Subject: License Amendment Request to Extend Diesel Generator Allowed Outage Time and Utilize Temporary Fuel Oil Storage Tanks on a One-Time Basis, Cooper Nuclear Station, NRC Docket 50-298, DPR-46

**LICENSE AMENDMENT REQUEST TO EXTEND DIESEL GENERATOR ALLOWED
OUTAGE TIME AND UTILIZE TEMPORARY FUEL OIL STORAGE TANKS ON A
ONE-TIME BASIS**

Cooper Nuclear Station, NRC Docket 50-298, DPR-46

ATTACHMENT 2
PROPOSED TECHNICAL SPECIFICATIONS
MARKUP FORMAT

Configuration During Tank Coating (Shown for "A" Tank)

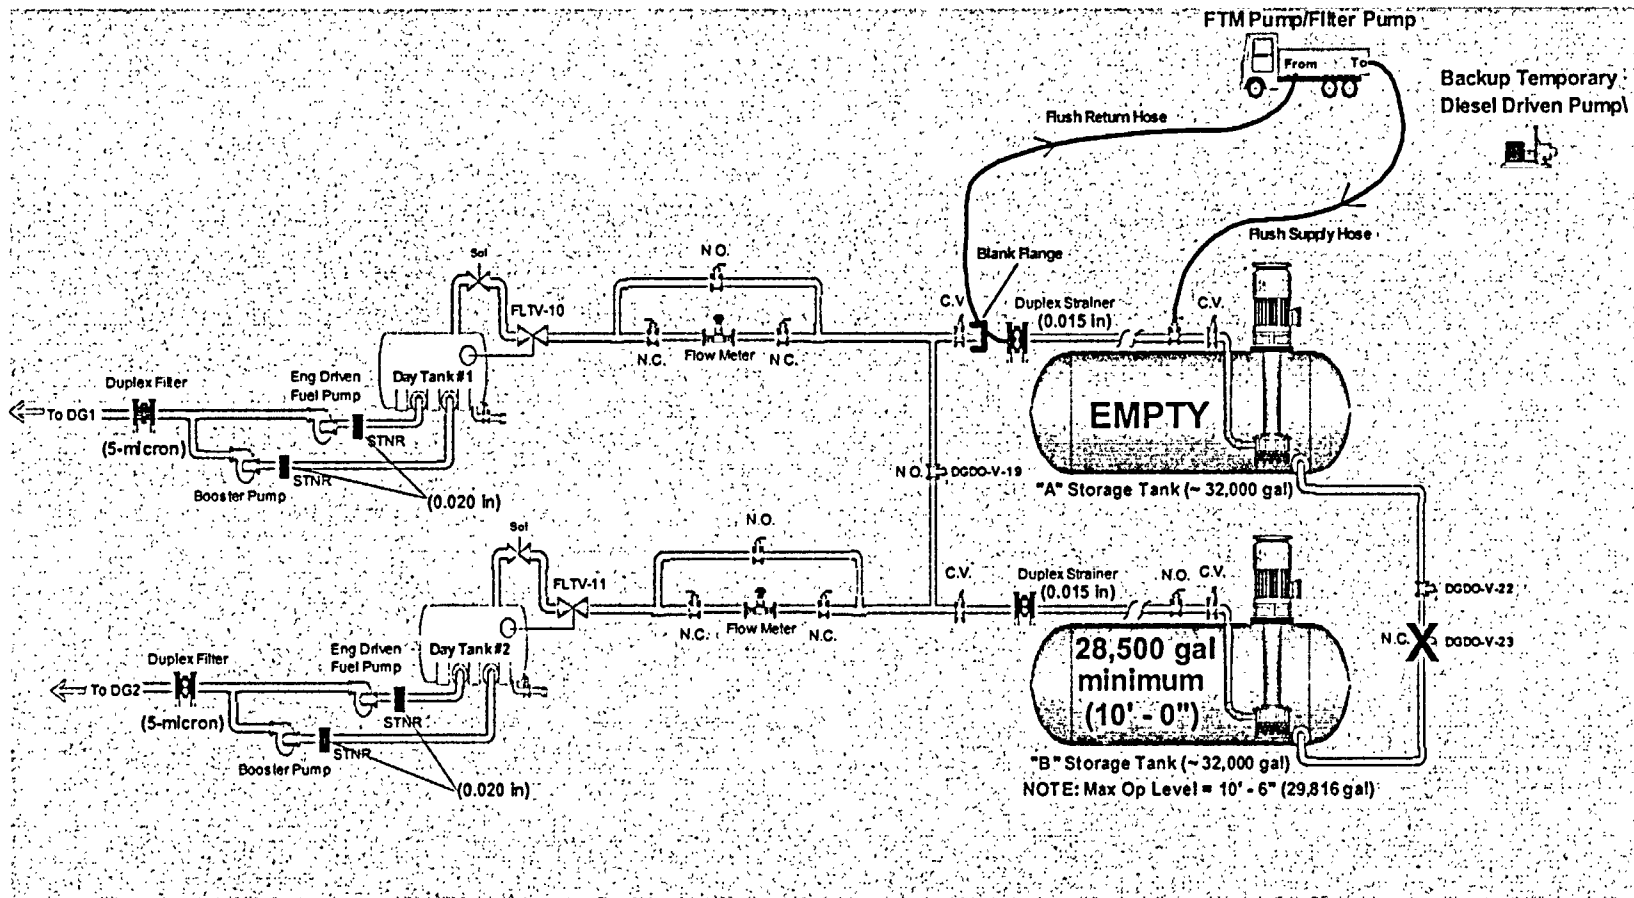
During tank cleaning and coating activities, the affected storage tank and transfer pump will be isolated from the system. Part of the fuel will be transferred from the isolated tank to the in-service tank to establish a minimum volume which supports greater than 4 days of DG operation at full load. The transfer pump will be electrically isolated by opening the associated Motor Control Center 480 volt breaker. A normally open cross-tie at the day tanks will be closed to allow installation of a blank flange to isolate the transfer piping. Once the blind flange is installed, the cross-tie at the day tank will be re-opened to allow the in-service storage tank and transfer pump to supply fuel to either of the day tanks. The remaining fuel will be transferred to a temporary tank and as necessary, a temporary overflow tank. Attachment 5, Figure 2, illustrates the normal Fuel Oil Transfer System configuration. Attachment 5, Figure 4, illustrates the Fuel Oil Transfer System temporary configuration during the cleaning and coating activities.

Defense in Depth Strategy #3 – Response to a Loss of Power to the Available Fuel Transfer Pump (Shown for "A" System Drained)

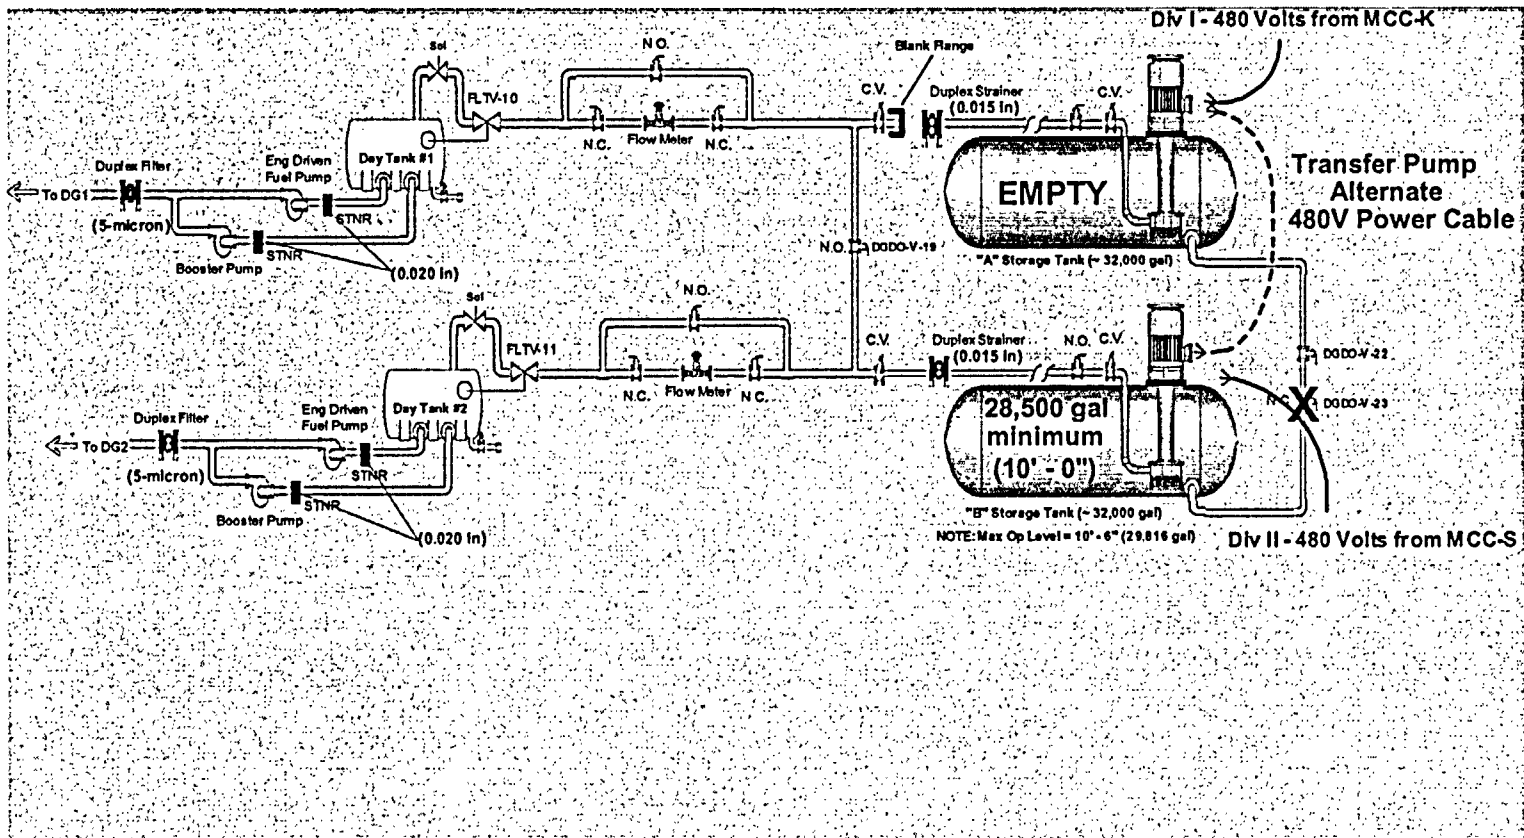
In the event of a loss of power to the operable fuel oil transfer pump, a pre-staged 480 volt AC jumper cable will be used to permit powering the affected pump from the opposite division's emergency AC power (Attachment 5, Figure 8). Existing control circuitry provides automatic day tank level control with the pump control switch placed in the "AUTO-ALTERN" position which provides a pump start signal at the day tank "Low Low" level.
